INDIANA DEPARTMENT OF ENVIRONMENTAL MANAGEMENT

Re: Confined Feeding Operation
Approval Renewal
Reauthorization of Construction
Approval Facility Change
Top Grade Production LLC
Howard County
Farm ID #3713
Animal Waste Number AW-6822

TOP GRADE PRODUCTION LLC
 2667 EAST STATE ROAD 18
 KOKOMO, INDIANA 46901
 2024 CFO RENEWAL-#3713

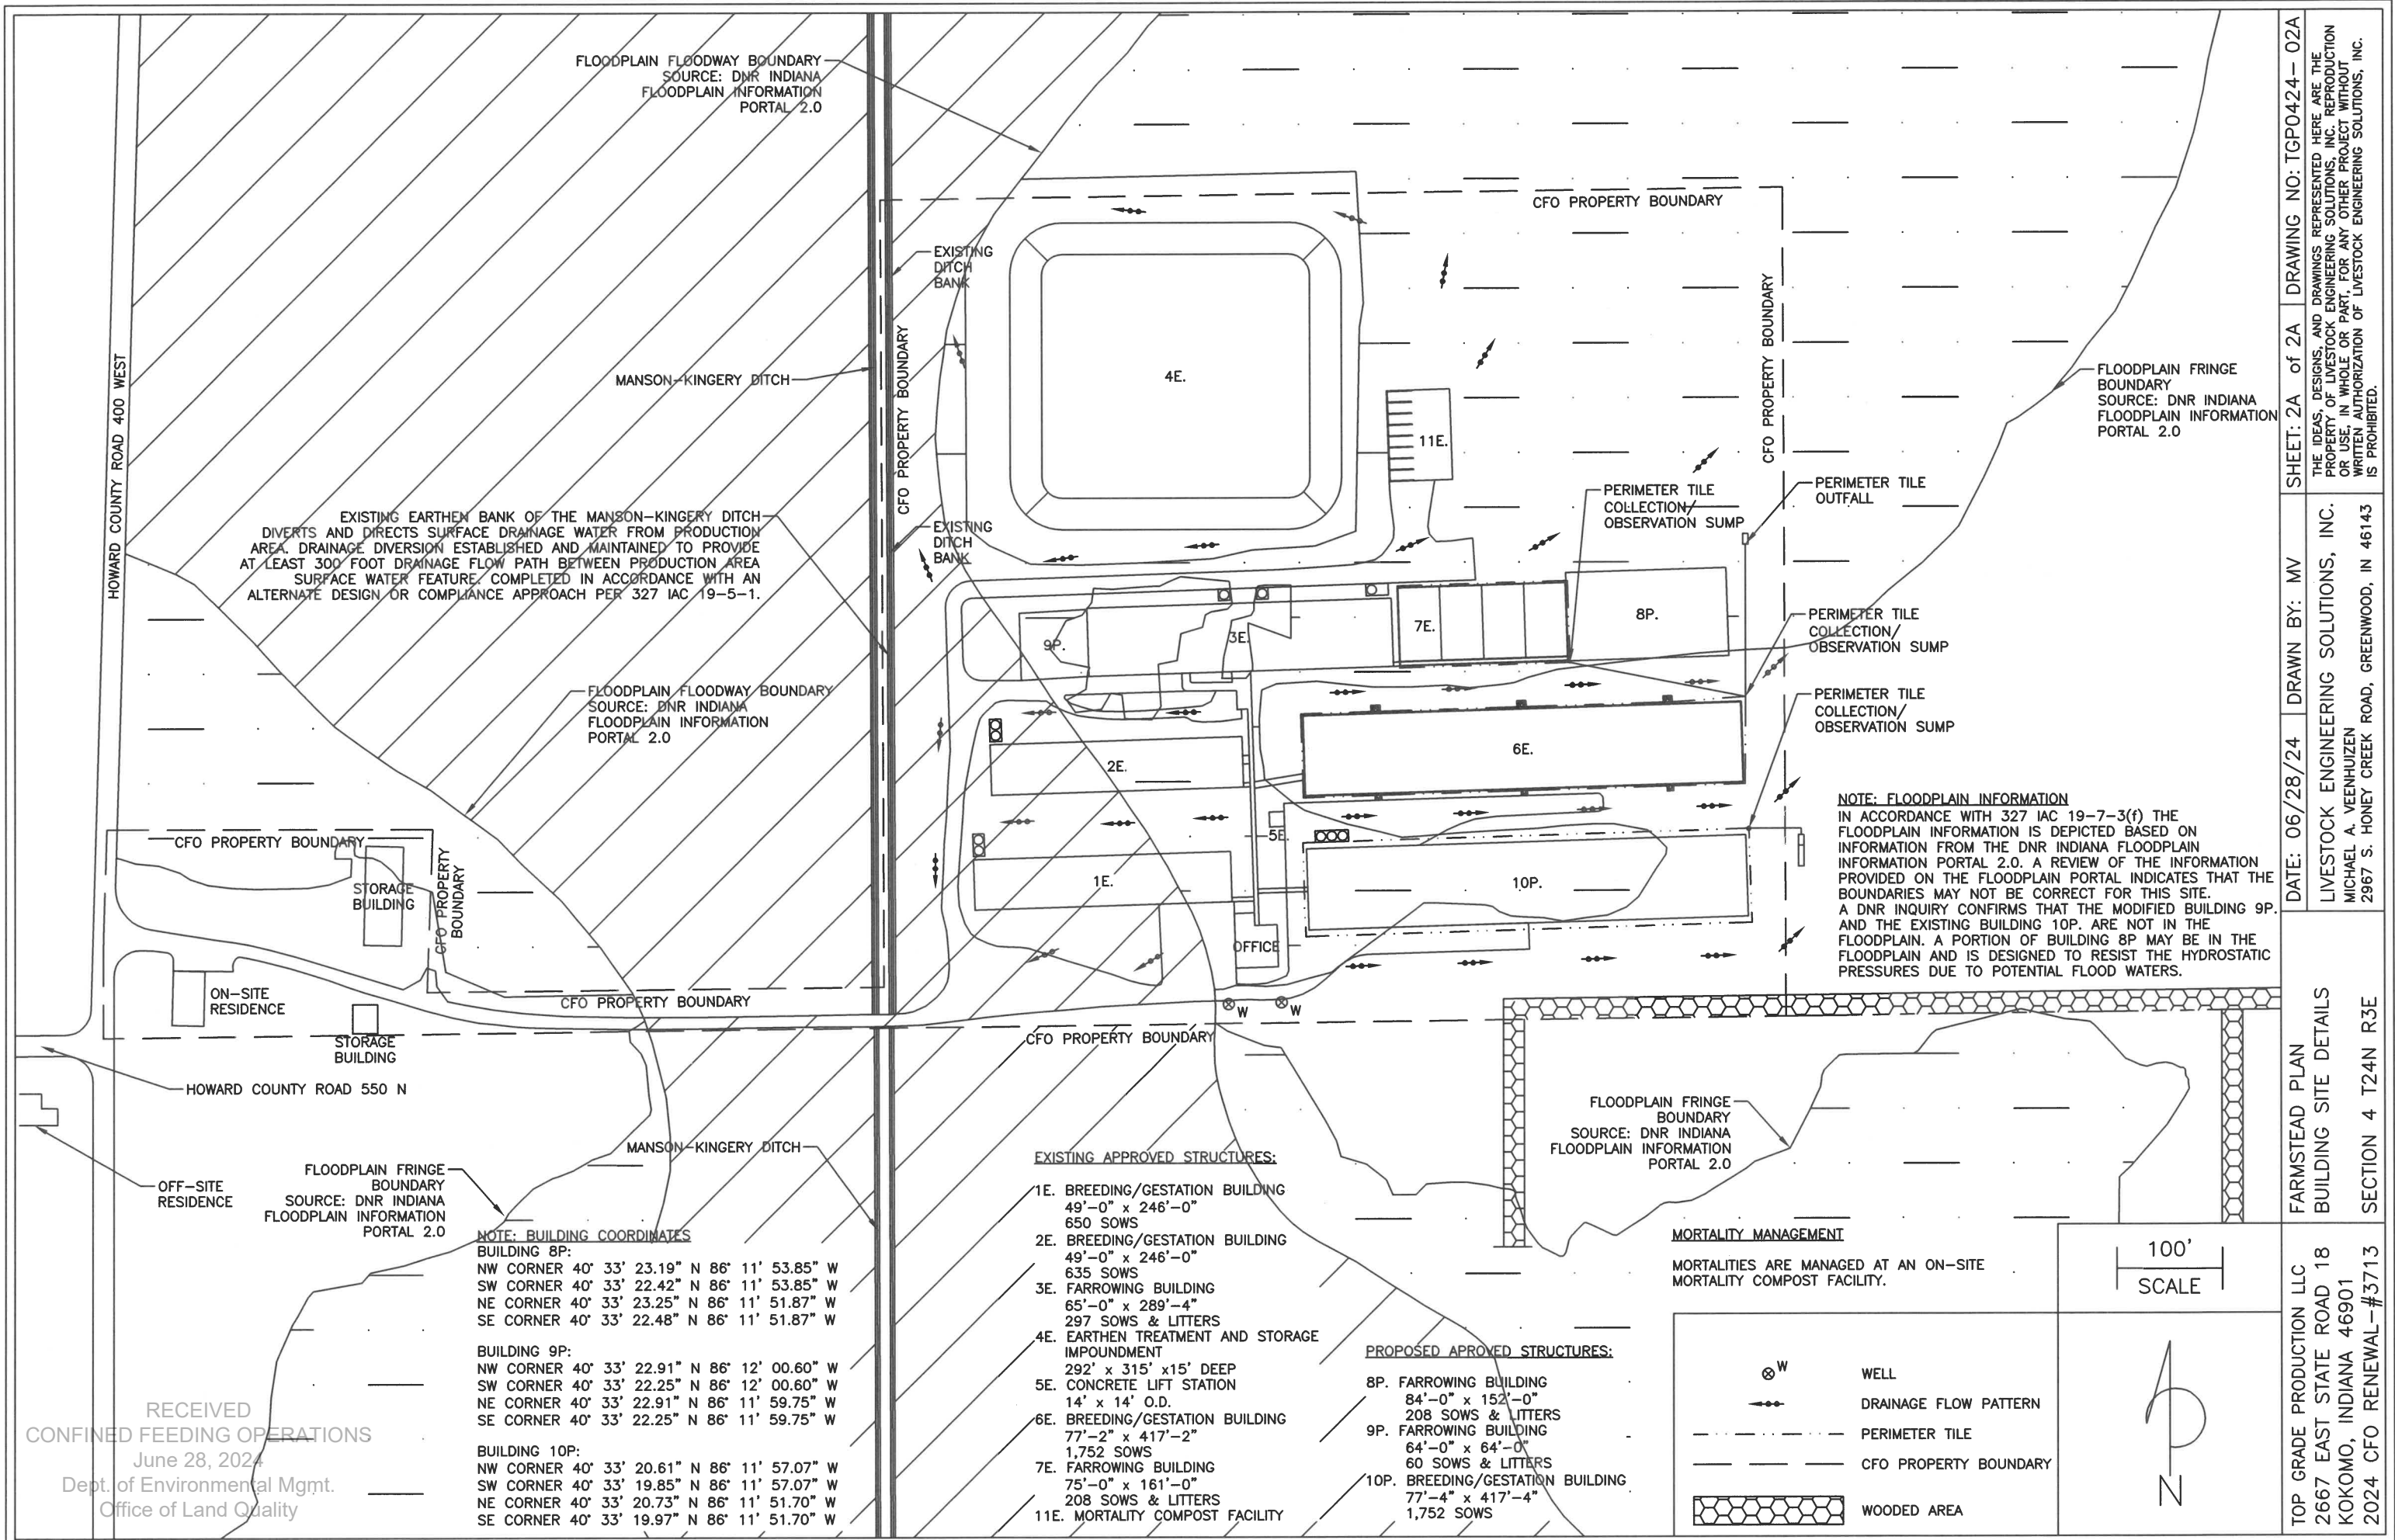
- The designs of swine confinement structures 8P and 9P have been modified to accommodate the floodway and floodplain fringe that have been mapped on the site after the structures were originally approved.

- Updated Farmstead Plan Sheet 2A to include floodplain and updated building dimensions and operating capacity. A copy of the DNR Indiana Floodplain Information Portal 2.0 map for the confined feeding site is added to show the current floodplain floodway and fringe boundaries depicted on Farmstead Plan Sheet 2A. (plan sheet 2A and floodplain map)

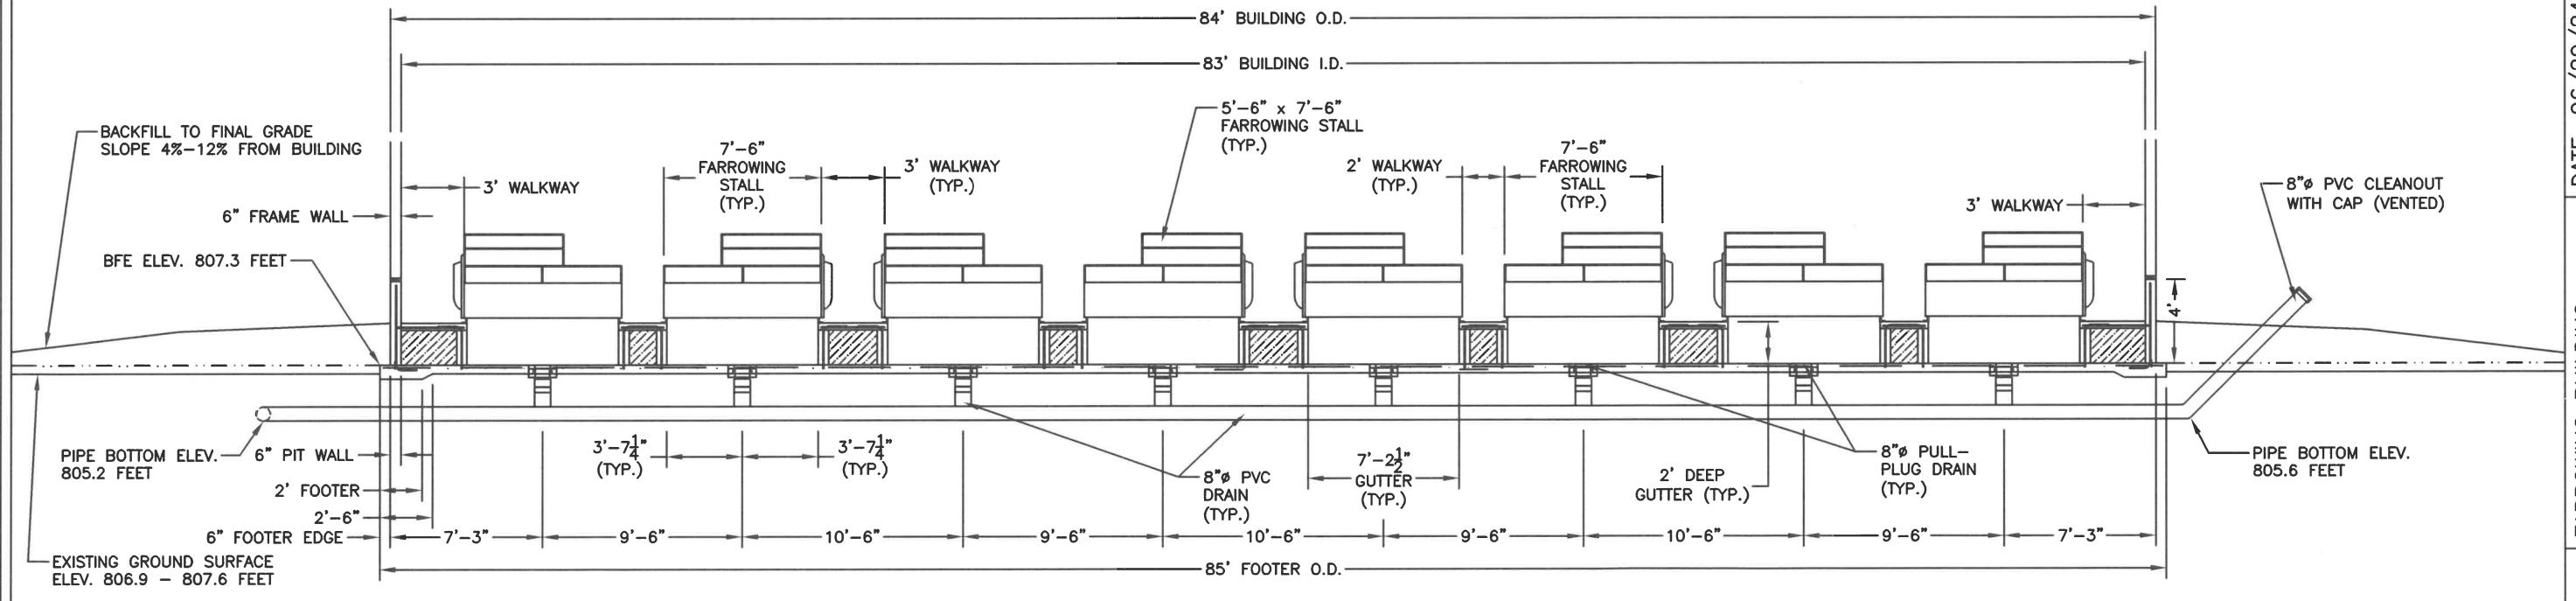
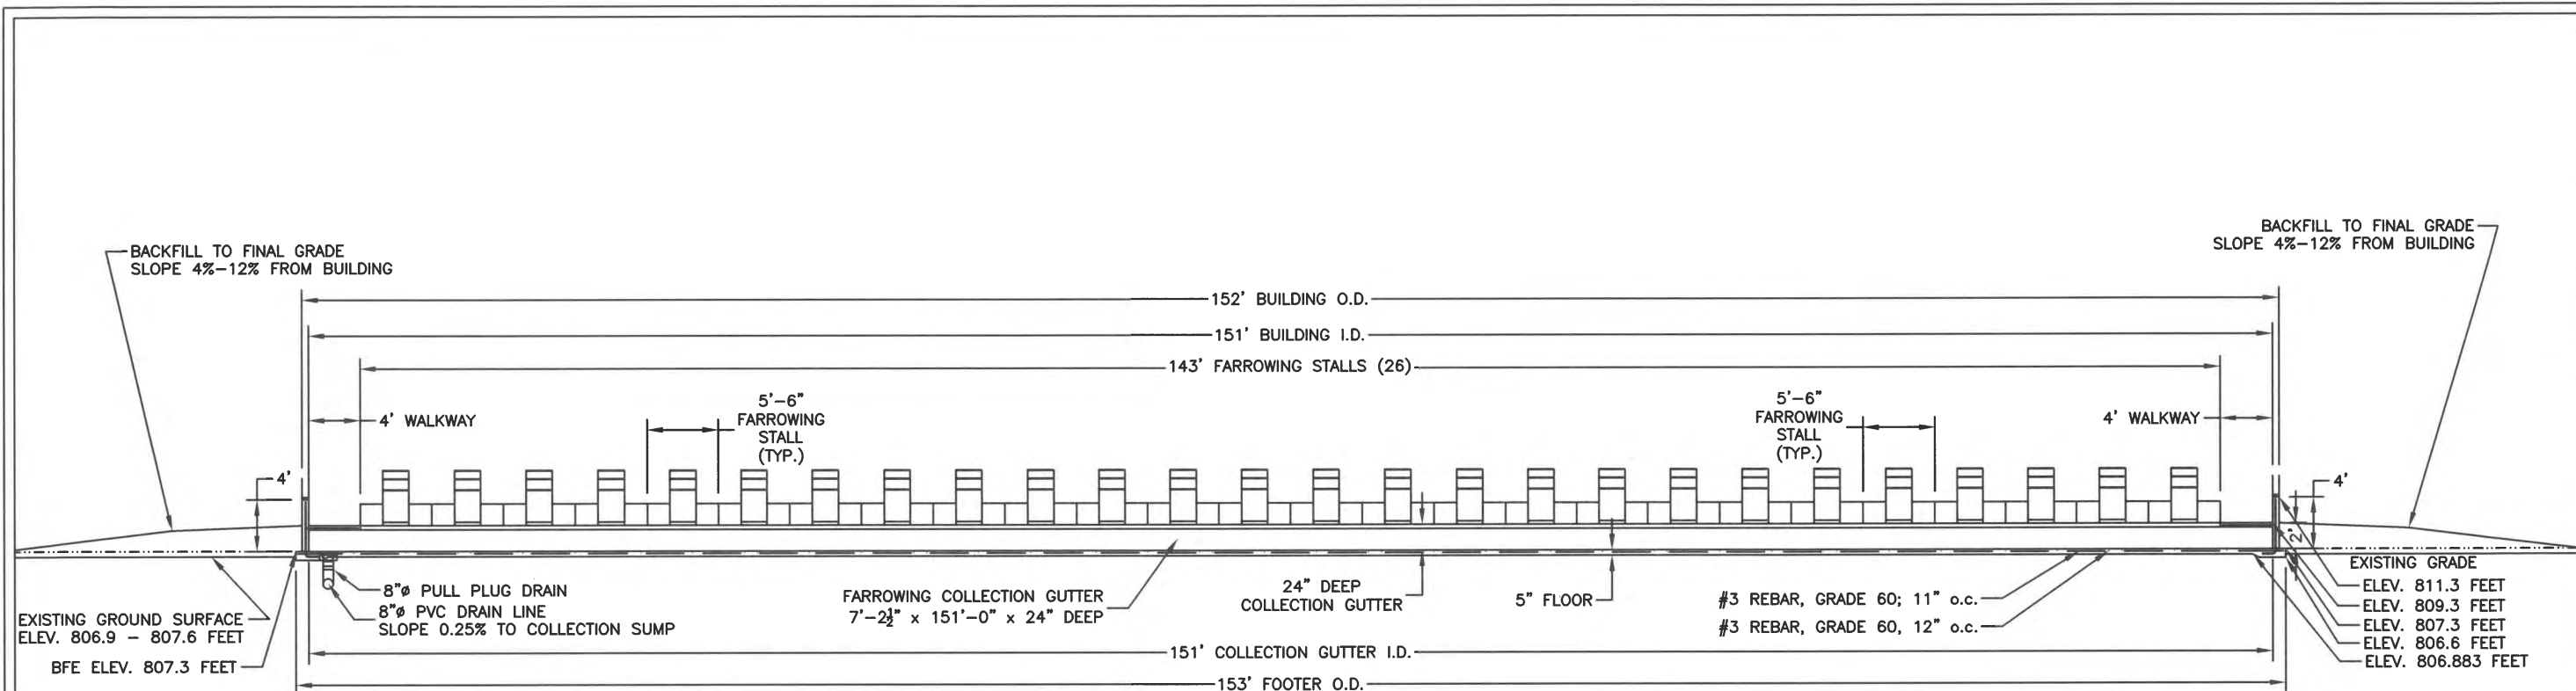
3. Plan Sheet 2B of 8B: Thank you for the opportunity to review the details shown on the plan sheets. A review of plan sheet 2B confirms that Detail B-3B faces west and Detail B-3B on plan sheet 3B is correct. It is noted that there are two clean-outs planned on the 8” diameter PVC gravity drain line. The clean-out on the north side of the building was not labeled. A label has been added to plan sheet 2B to identify the clean-out on the north side of the building. Referring to Detail B-3B on plan sheet 3B the cleanout located on the north side of the building is visible and is correctly shown on the right side of the page. The clean-out on the south side of the building is east of the Detail B-3B section line on plan sheet 2B and is not visible on plan sheet 3B when facing west.

Plan sheet updates: Plan sheets 2B and 3B have been updated to include the beginning and ending elevations of the 8" diameter PVC drain pipe. Updated plan sheets 2B and 3B are included.

A
3C CONCRETE PIT CROSS-SECTION
THRU FARROWING STALLS AND COLLECTION GUTTERS

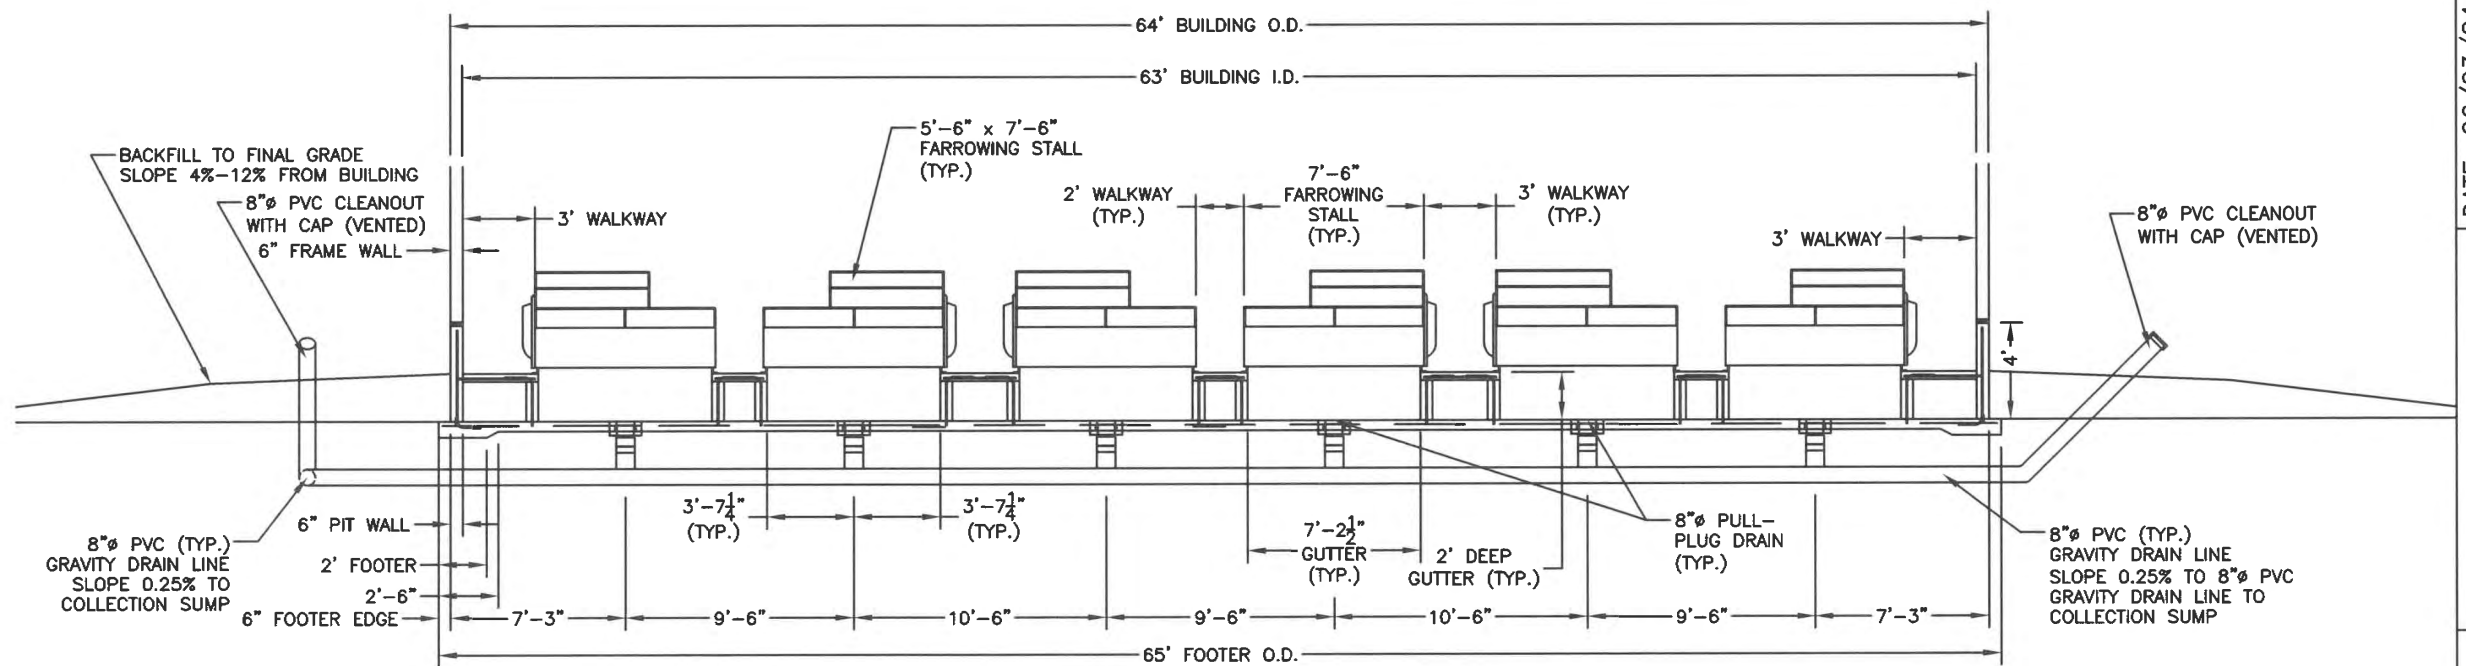
A review of plan sheet 2C confirms that Detail B-3C faces west and Detail B-3C on plan sheet 3C needs to be updated. There are two clean-outs planned on the 8” diameter PVC gravity drain line. The clean-out on the north side of the building was not labeled. A label has been added to plan sheet 3C to identify the clean-out on the north side of the building. Both clean-outs are visible when Detail B-3C section line is facing west. Plan sheet 3C has been updated to identify both of the planned clean-outs in Detail B-3C.
